OUR REF: 20208 – S4.55(8)

**RE: SECTION 4.55(8) MODIFICATION FOR DEVELOPMENT APPLICATION (DA NO. 7/2022/A)
NO. 129 DOVER ROAD, ROSE BAY**

This Section 4.55(8) Modification has been prepared for Sophie Spartalis and Michael Orphanides by George Karavanas Planning Pty Ltd – (hereafter referred to as GSA Planning). On behalf of the applicant, we hereby seek Council approval for a Section 4.55(8) modification of the approved development at the abovementioned site (DA No. 7/2022/A). The approval relates to the demolition of the existing structures and construction of a new dwelling with basement car parking accessed from Dover Road, and a new garage with a studio above accessed from Beaumont Street.

Figure 3: Approved and Proposed Basement Floor Plan

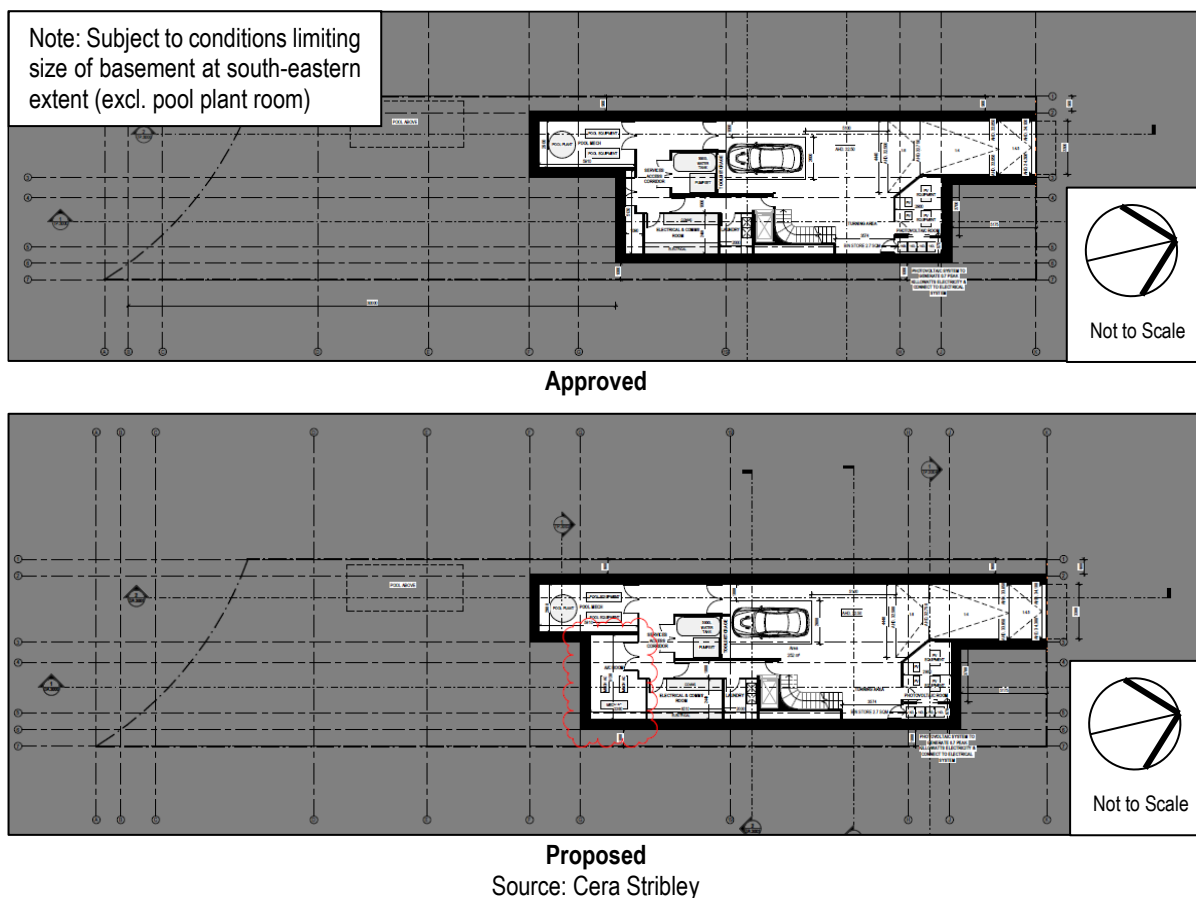
The Basement Floor Level is at RL 32.50 AHD (as approved). The proposed modifications include a small area of additional excavation to accommodate a sufficiently sized mechanical A/C and plant room (see **Figure 3**).

Room required to be a minimum internal size of 5130l x 3300w x 2400h. Plant and equipment required to have a minimum of 600mm clearance around, for future access and maintenance. Dual doors and access corridor required for installation and future removal of plant. Plant room layout has been reduced to the minimum size, to comply with the relevant governing standards and manufacture requirements. Refer to spatial compliance statement outlining particular standards.

Figure 4: Approved and Proposed Ground Floor Plan

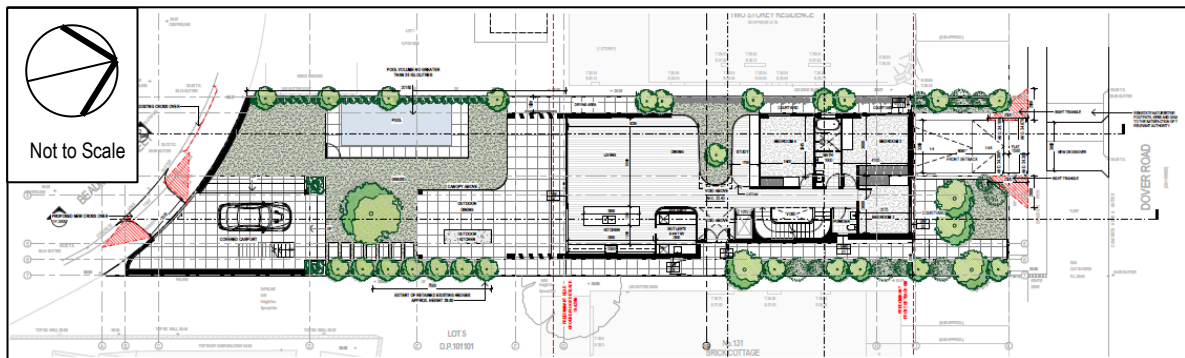
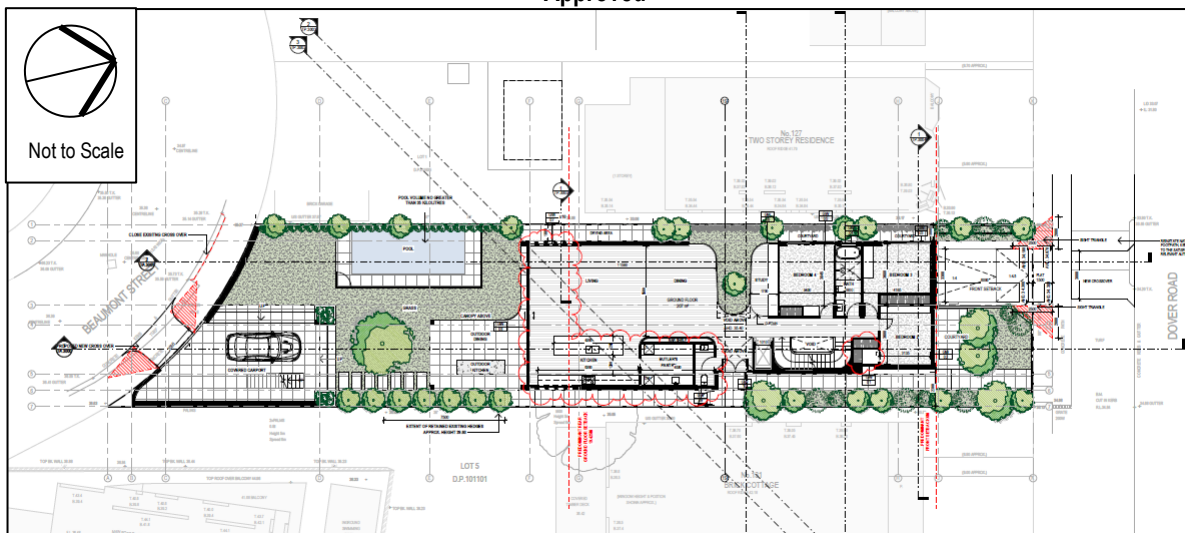
- Replacement of one powder room with a walk-in-robe; and
- Extension of the rear glazing line and added glazing to the approved blade walls at both side elevations to accommodate a new power room, expansion of the butler's pantry and a larger living, dining, and kitchen area (see **Figure 4**).

Figure 5: Approved and Proposed First Floor Plan

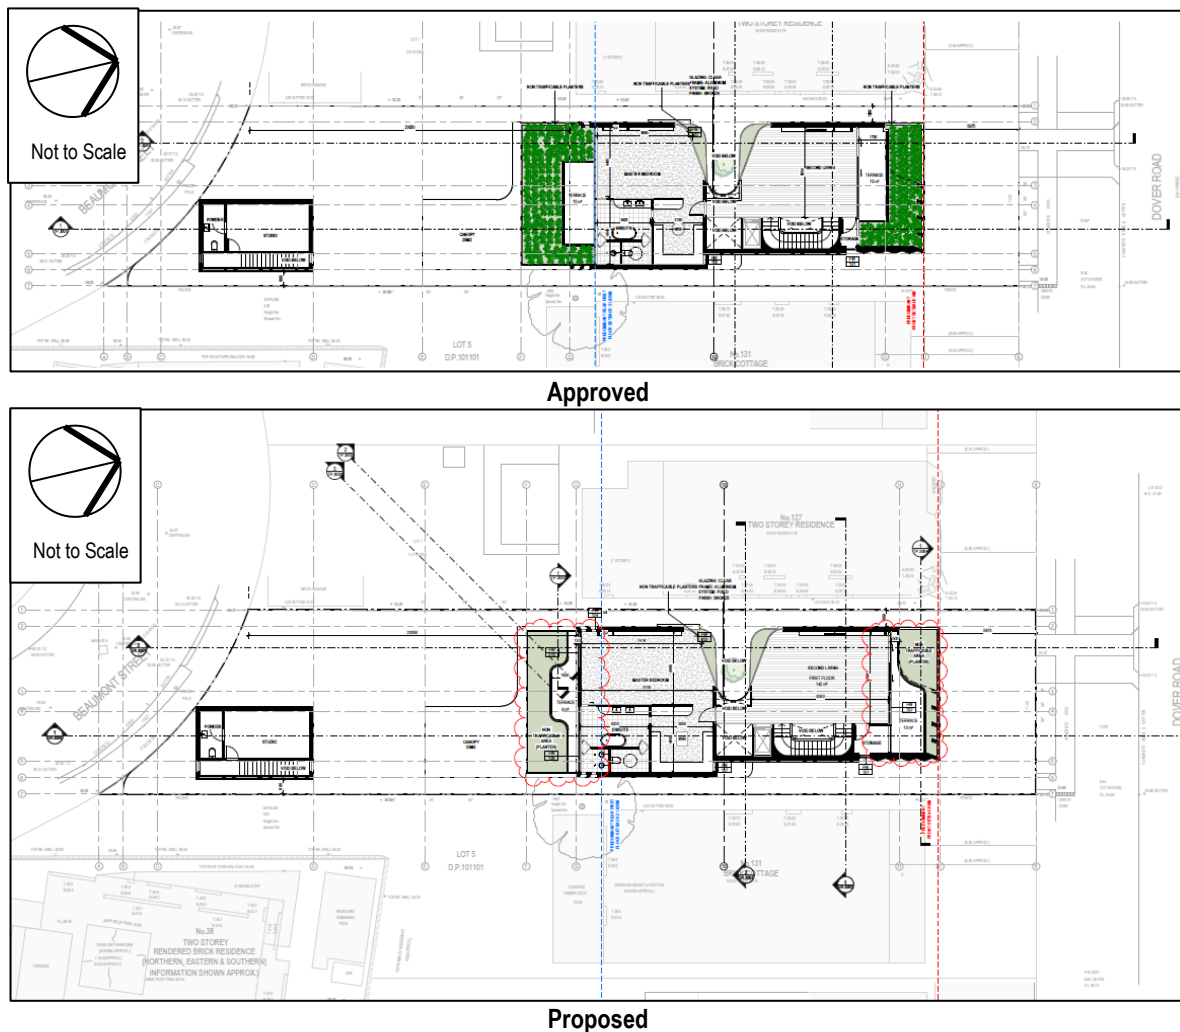
- Slight extension of the front glazing line, resulting in a larger living room and storage room, and an amended front terrace layout. The terrace is reshaped to remain at 10m² as approved and to preserve privacy for the adjacent residences; and
- Extension of the rear glazing line and added glazing to the approved blade walls at both side elevations, resulting in a larger master bedroom, ensuite and walk-in-robe, and an amended rear terrace layout. The terrace will reduce in size from 10m² to 9m² (see **Figure 5**).

Figure 6: Approved and Proposed Ground Floor Plan

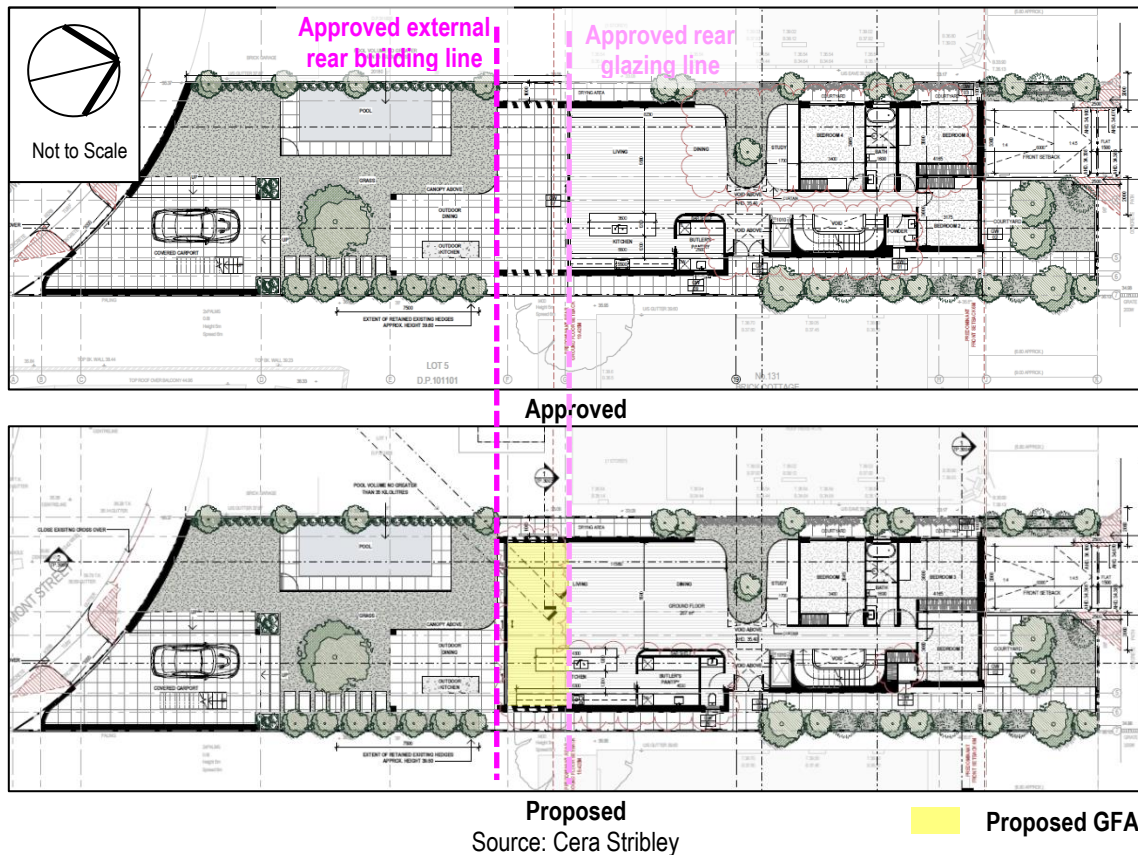
The following **Figures 6 & 7** show the areas of additional GFA in comparison to the approval.

Figure 8: Approved and Proposed Front Balcony

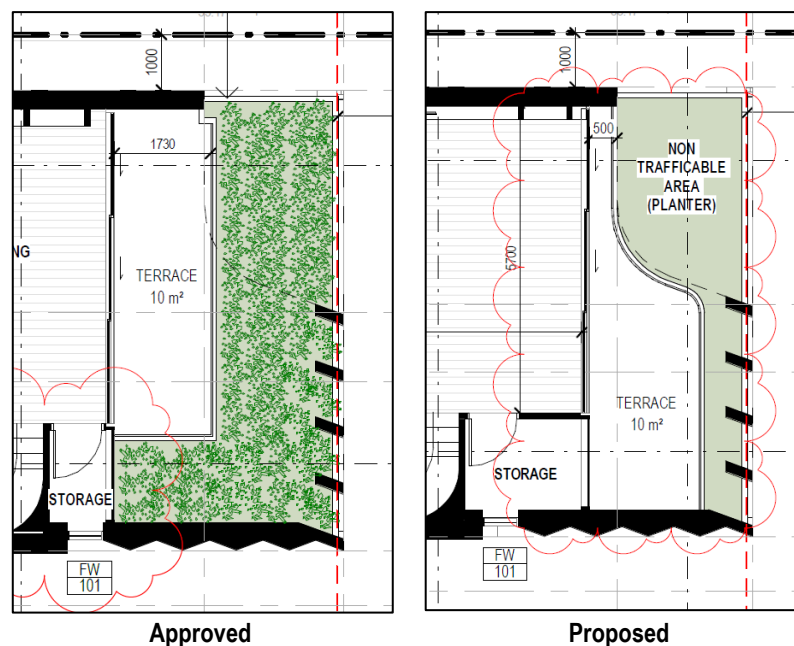
This change is a result of design development, resulting in a reshaped balcony layout. Importantly, the redesigned front balcony locates the balcony further away from No. 127 Dover Road, in order to ensure there are no direct lines of site to the windows of this neighbouring development. This preserves and enhances privacy for both the residents of the neighbouring property and the subject site.

The front facing balcony will preserve privacy to neighbouring properties. The balcony is proposed to be narrow (0.5m deep) toward the west, and 2m deep toward the east. The approved solid blade wall at the east elevation obstructs any views to No. 131 Dover Road, while the reshaped extent of the terrace prevents sightlines to the angled window at No. 127 Dover Road. The size of this balcony remains as approved at 10m², and as such, noise generation is not anticipated to change from what was approved.

Figure 9: Approved and Proposed View from Neighbouring Development, Demonstrating No Discernible Change from the Approval

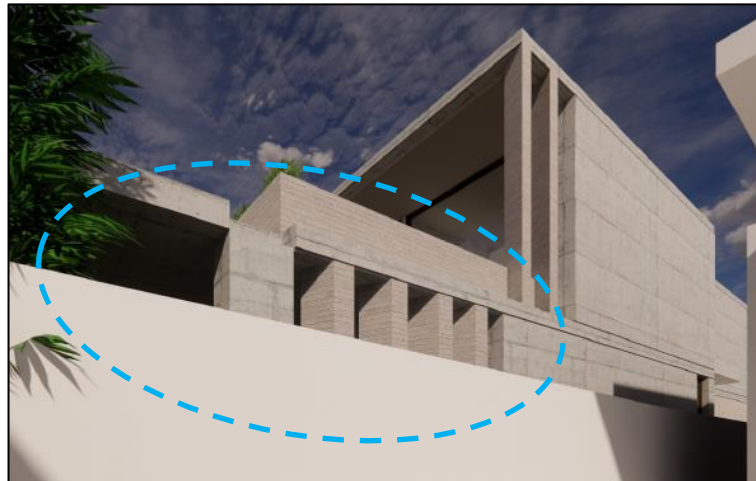
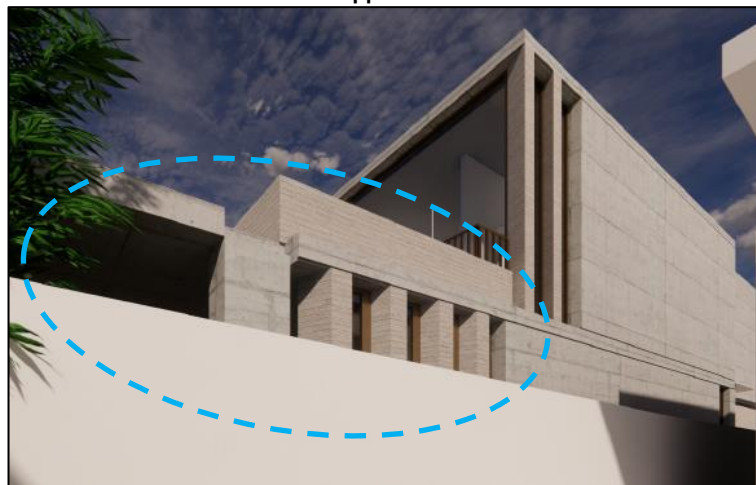
Notably, the proposed modification retains the approved side blade screens, with clear glazing provided behind these screens to discretely enclose the new internal spaces. This design approach ensures there is no change to the visible bulk, scale or setbacks of the development when viewed from Nos. 127 and 131 Dover Road, in comparison to the approval (see **Figure 9** on the following page).
